**Environmental Impact Statement (EIS)
assessment report under the
*Environmental Protection Act 1994***

Moranbah South Project
proposed by Anglo American Metallurgical Coal Pty Ltd

Prepared by: Statewide Environmental Assessments, Department of Environment and Heritage Protection

August 2014

Figure 1 Moranbah South Project location and mine layout (Source: EIS Figure 3)

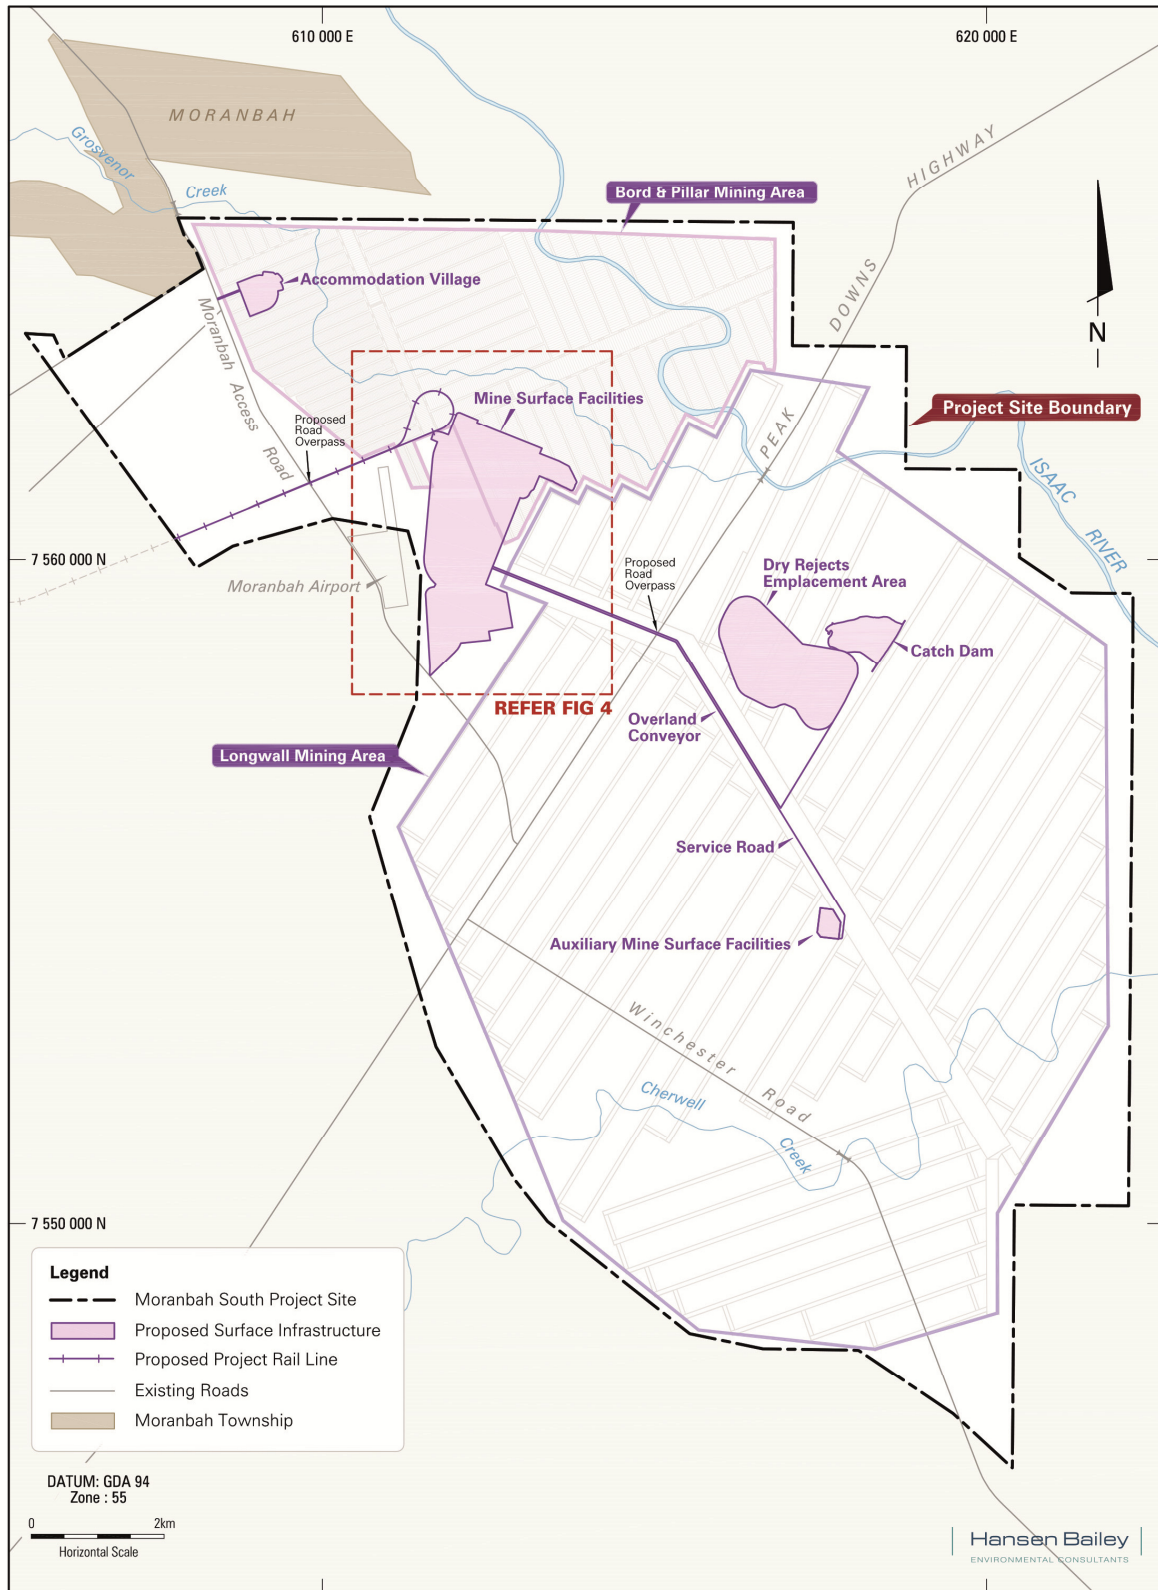
Another issue TMR had was that the proposed longwall panels that are shown to be perpendicular to Moranbah Access Road and Winchester Road (Figure 1; Figure 4). While TMR stated that these roads are not TMR administered roads, the intersection with Peak Downs Highway is administered by TMR. TMR stated that there was no mention made regarding the approach sight distance and pavement condition to be maintained during and following the completion of mining activity. TMR requested further information from the proponent confirming appropriate sight distance to intersections will be maintained.

Figure 3 Surrounding land use (Source: EIS Figure 5-2)

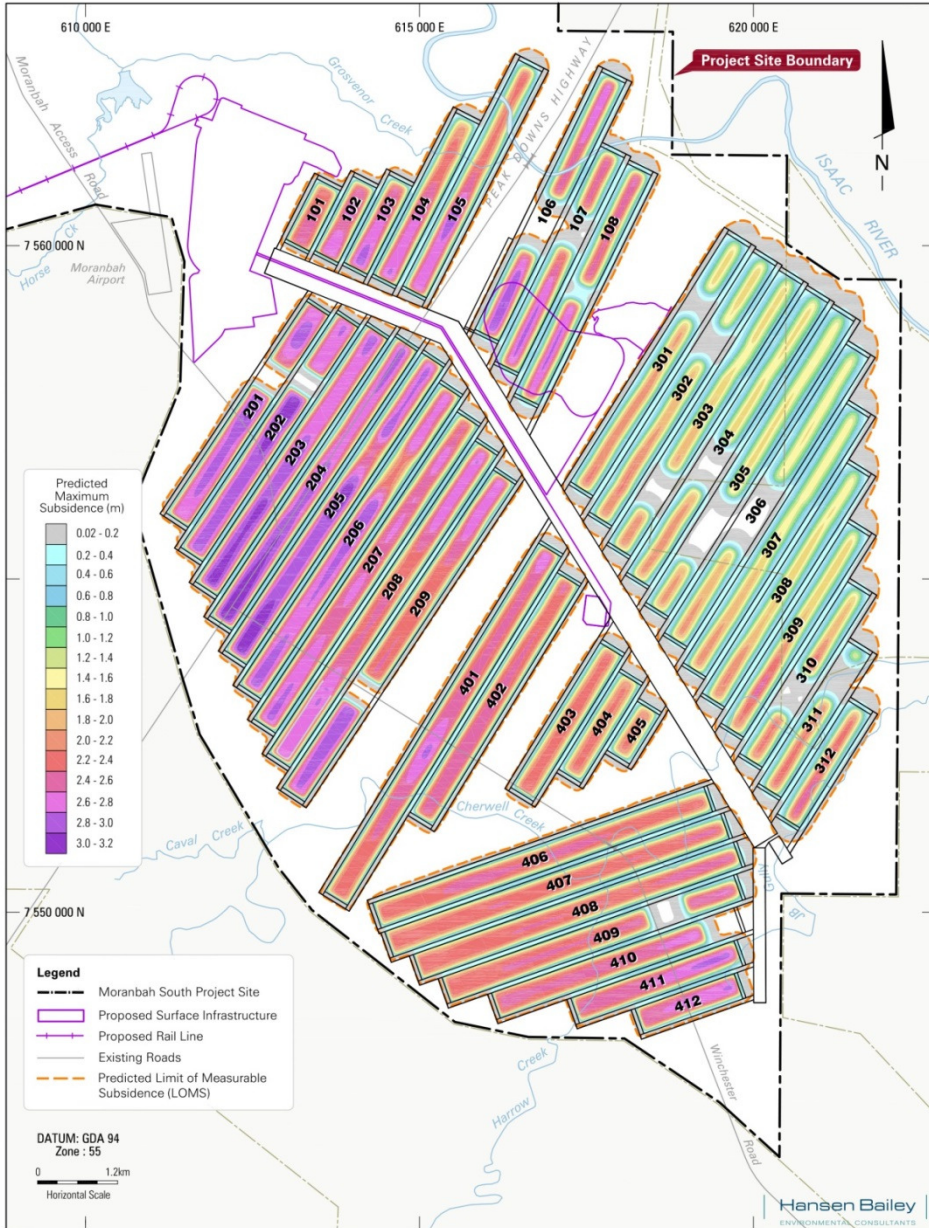
The proposed Isaac Plains South Project open cut mine site would overlap the eastern part of the proposed project site (referred to as the 'overlap area', refer to section 2.6 and Figure 3 for more information). In accordance with an agreement between the proponents of the two projects, the proposed project would only mine in the overlap area once the proposed Isaac Plains South Project mining is complete. The proposed Moranbah South Project would be responsible for repairing any damage caused by subsidence of the proposed Isaac Plains South Project's rehabilitated overburden emplacement areas, levee and stream diversion within the overlap area.

Figure 4 Predicted maximum vertical subsidence (Source: EIS Figure 6-2)

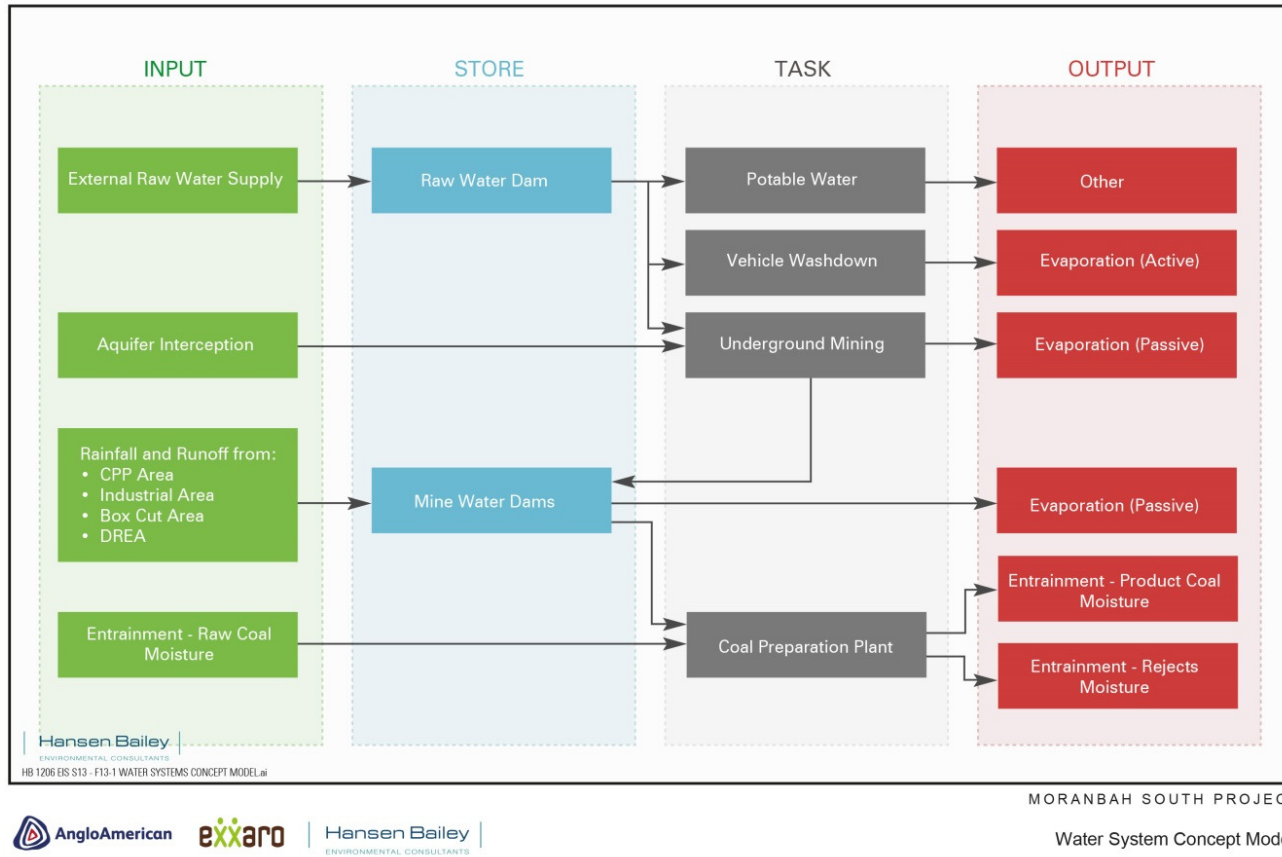
- Predicted maximum vertical subsidence of 3.2m. The maximum vertical subsidence would occur in the western part of the mining area where the depths of cover are the shallowest (Figure 4).
